ILLUSTRATIVE SITE DESIGNS
FOR
MULTI-FAMILY HOUSING IN PASADENA

Prepared for the Pasadena
Multi-Family Housing Task Force

Daniel Solomon and Associates
Daniel Solomon
Kathryn Clarke
Susan Haviland

DSA 16.12

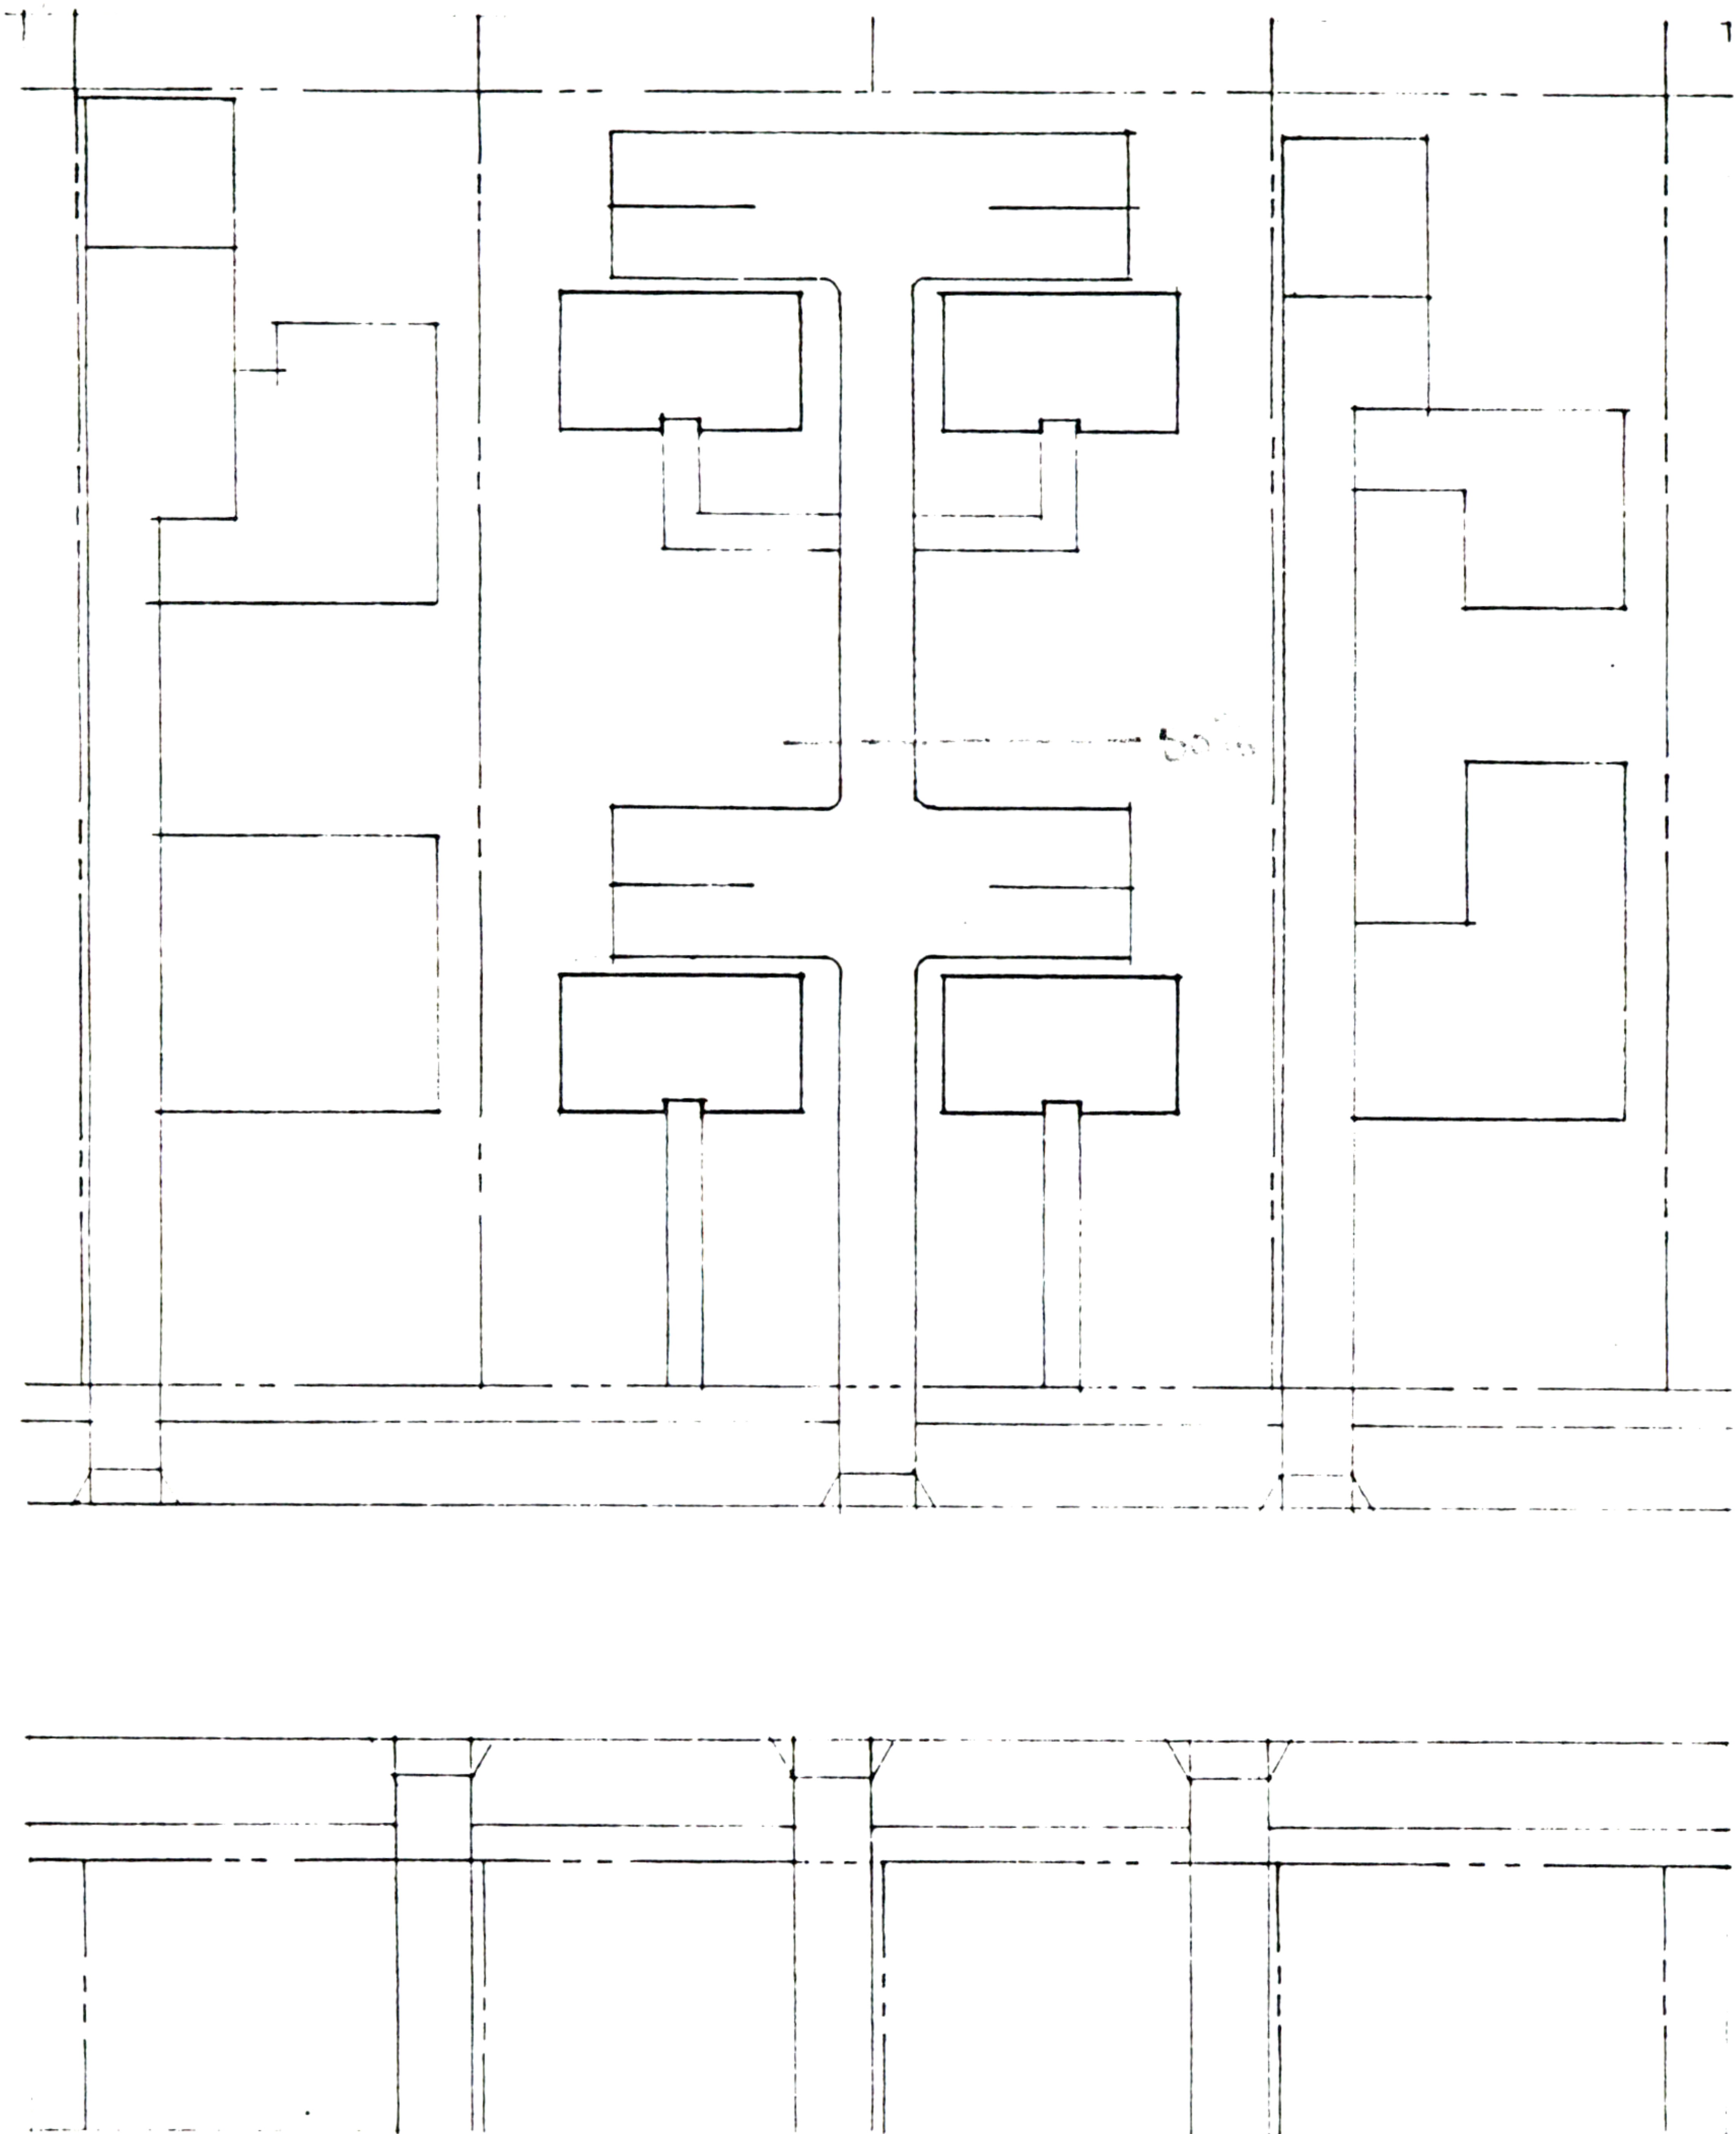
PARKING OVER REAR 50% LOT LINE!

DSA 16.20

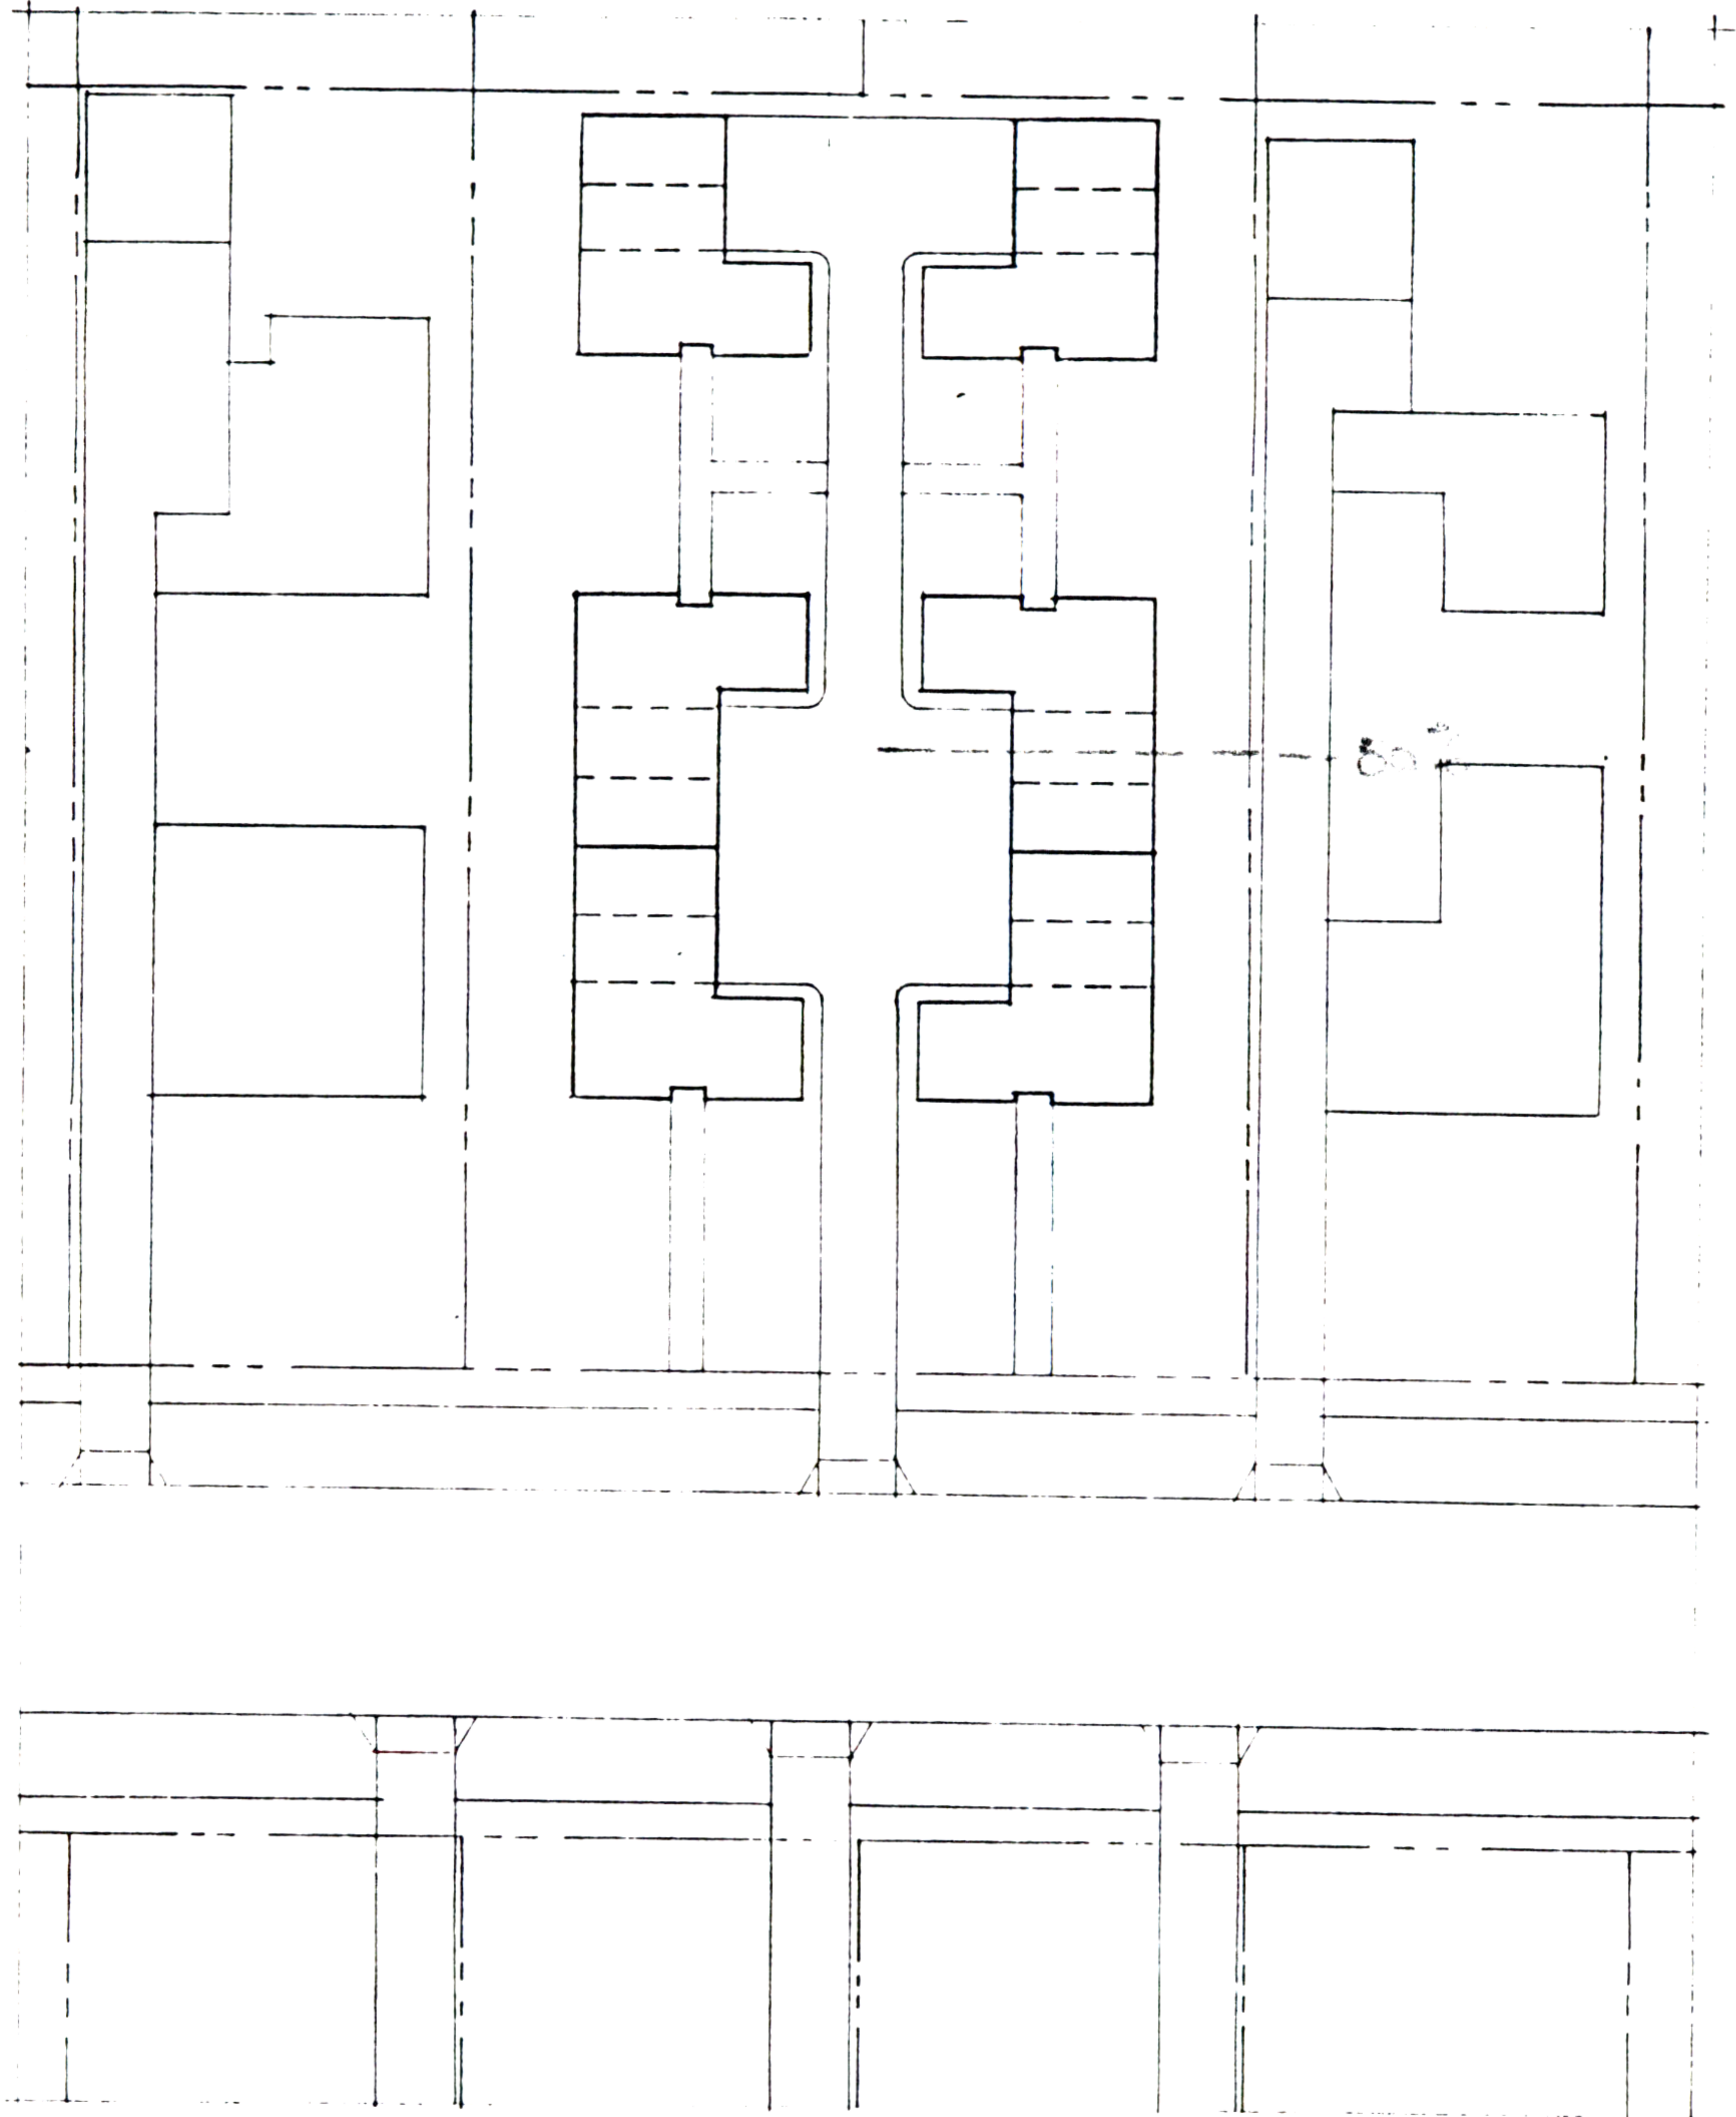
PARKING IS OVER REAR 50% LOT LINE!

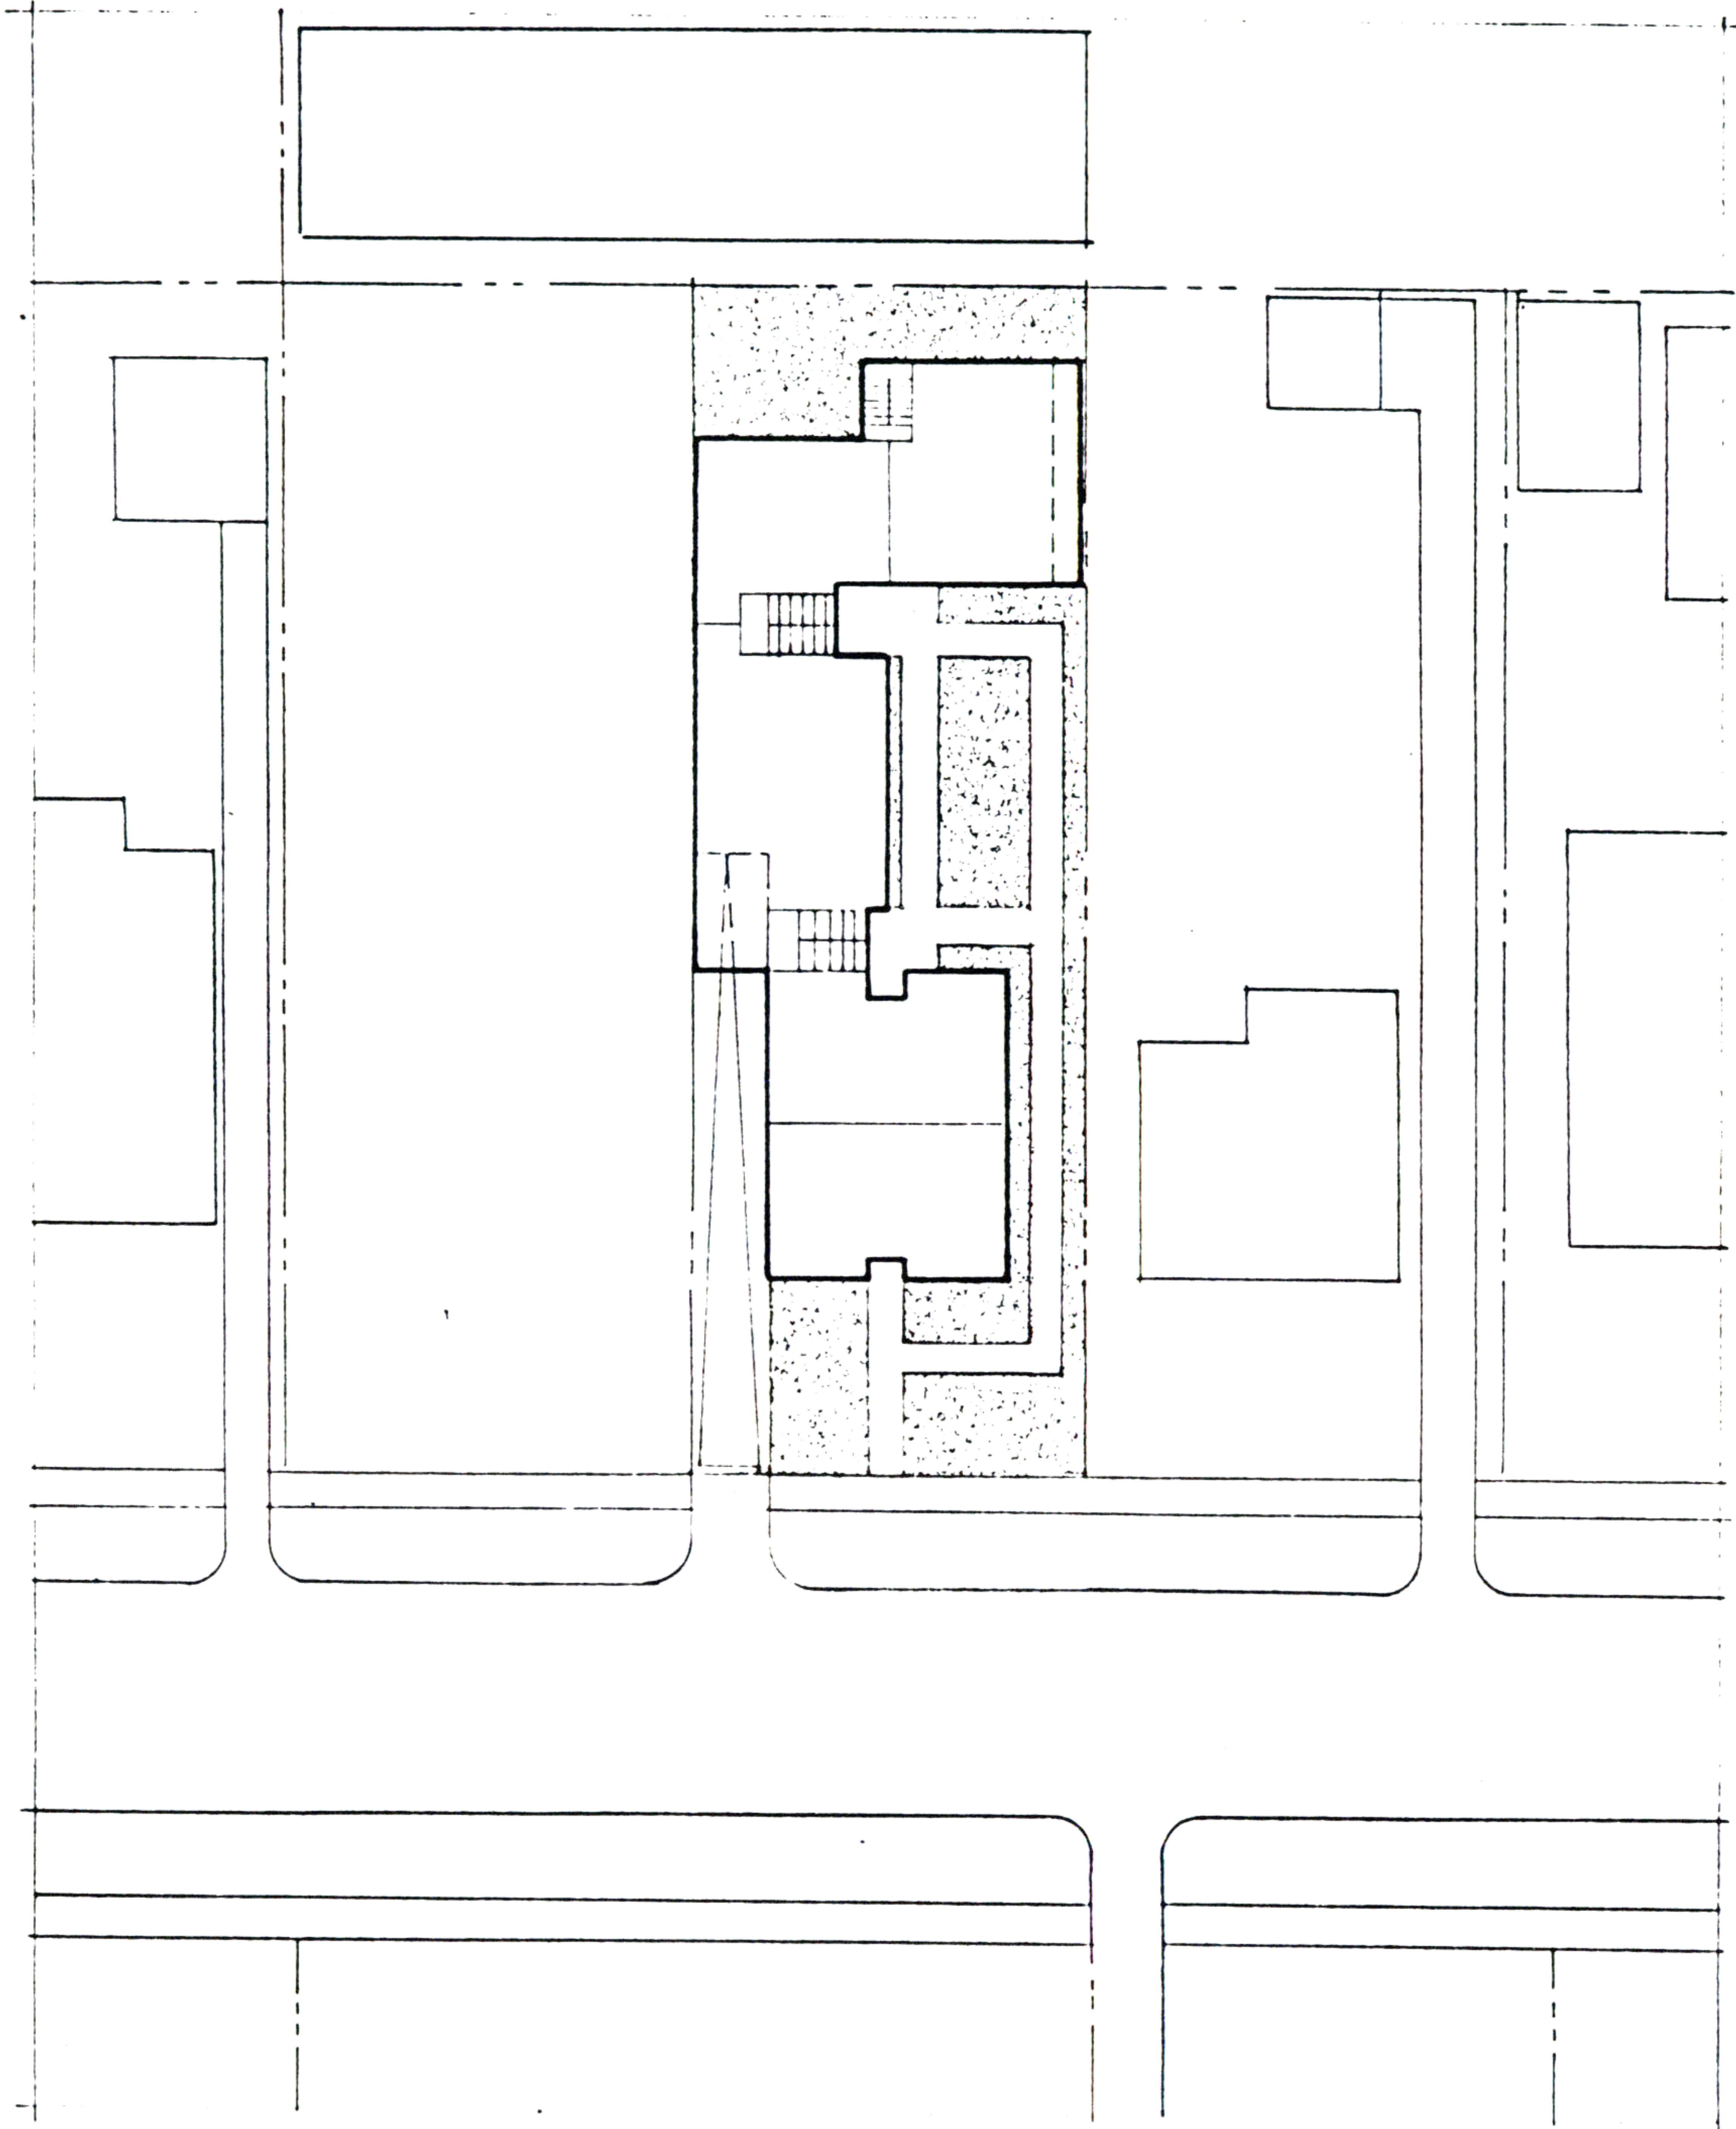
NO NUMBERS GIVEN!
